# 1968 Corvette: Service News: Tune-up Specification Change

**Subject:** Tune-up Specification Change

**Model and Year:** 1968 Corvette with 427 cu. in. Engine, Manual Transmission and Air Conditioning

**Date:** February 1968, Volume 40, Issue #2

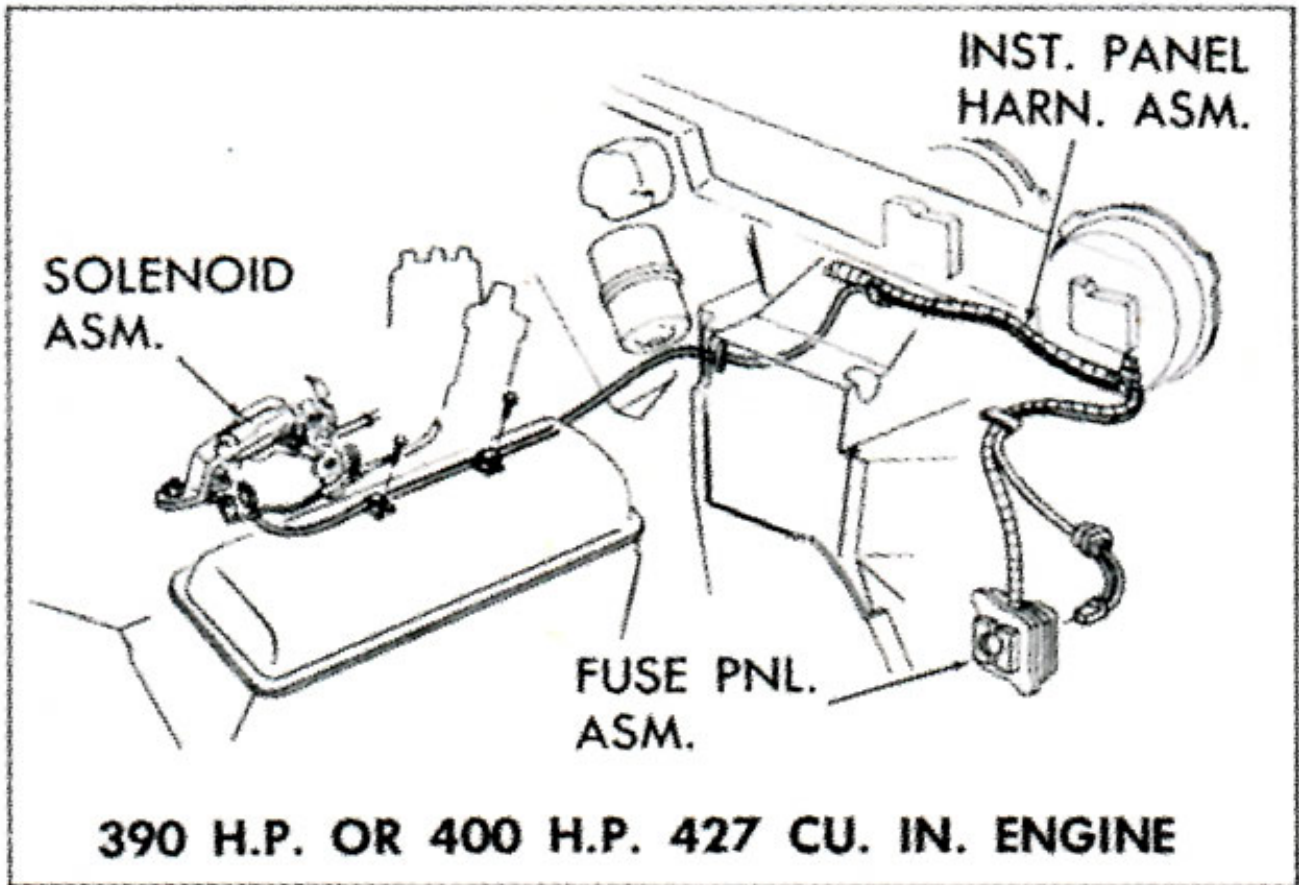
If the anti-dieseling solenoid on one of these vehicles requires replacement or adjustment, refer to the procedures given on Page 7 of this Service News issue. The 'Anti-Dieseling Solenoid Diagnosis Chart' on Page 7 of this issue should be of assistance in determining whether replacement is necessary. Figure 6 illustrates proper solenoid wire routing for either the 390 or 400 H.P. engine. The connector at the use panel should be inserted in the receptacle marked "IGN" for proper solenoid operation.

Fig. 7—Anti-Dieseling Solenoid Installation

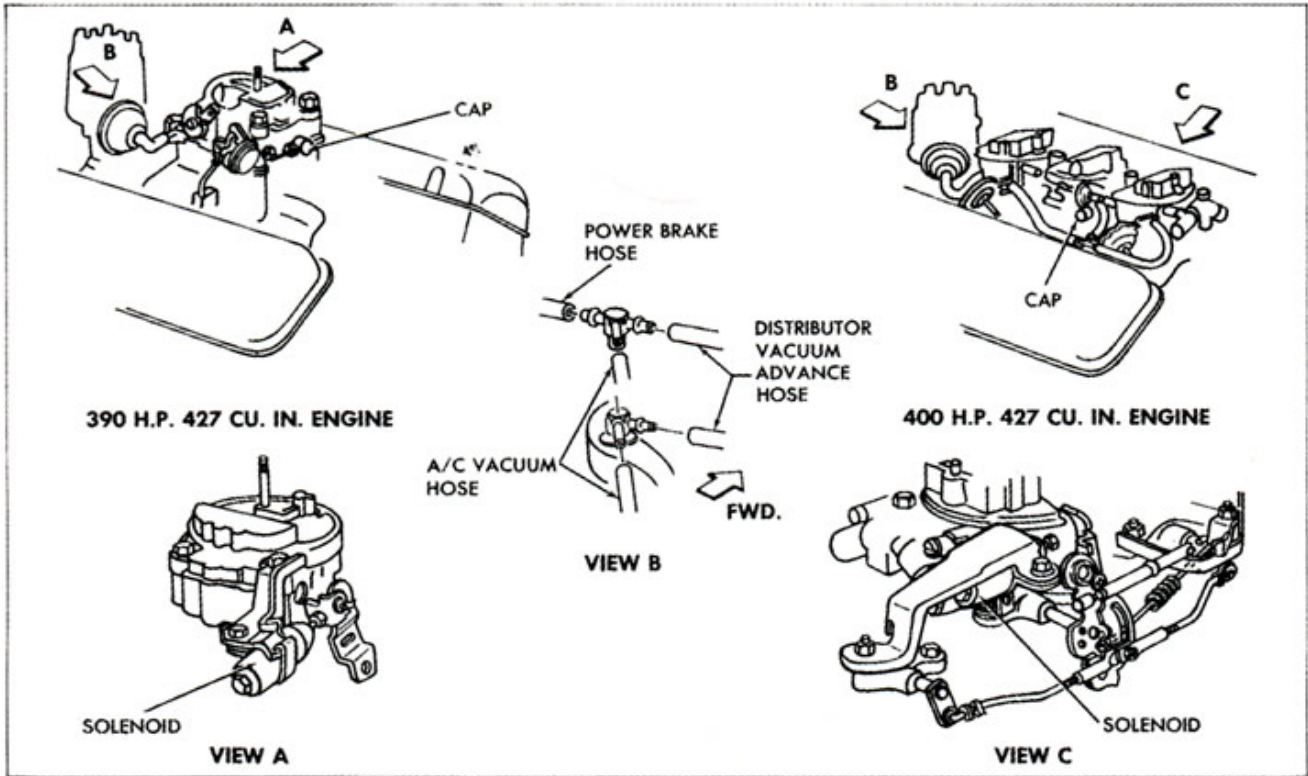
Figure 7 illustrates proper solenoid installation on both the 390 H.P. and 400 H.P. versions of the 427 cu. in. engine and also illustrates the correct intake manifold vacuum fittings for the full manifold vacuum distributor advance arrangement.
